PRODUCT/PROCESS CHANGE NOTICE (PCN)

PCN #: N1703-01 Date: May 2, 2017 Product Affected: 8V97053NLGI 8V97053NLGI8 8V97053NLGI/W Date Effective: August 2, 2017	MEANS OF DISTINGUISHING CHANGED DEVICES: <input checked="" type="checkbox"/> Product Mark Prefix character on date code line as shown on Attachment 1 <input type="checkbox"/> Back Mark <input type="checkbox"/> Date Code <input type="checkbox"/> Other
Contact: TSD Clock Team E-mail: clocks@idt.com	Attachment: <input checked="" type="checkbox"/> Yes <input type="checkbox"/> No Samples: Samples are available now.

ATTACHMENT 1 - PCN #: N1703-01

Example of Prefix character change in datecode line

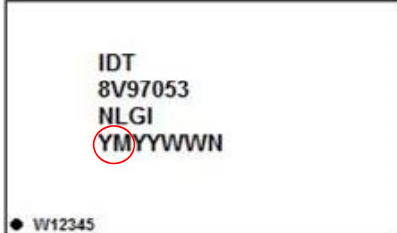
From: YI	To: YM
 <p>IDT 8V97053 NLGI YIYYWWN</p> <p>● W12345</p>	 <p>IDT 8V97053 NLGI YMYWWN</p> <p>● W12345</p>
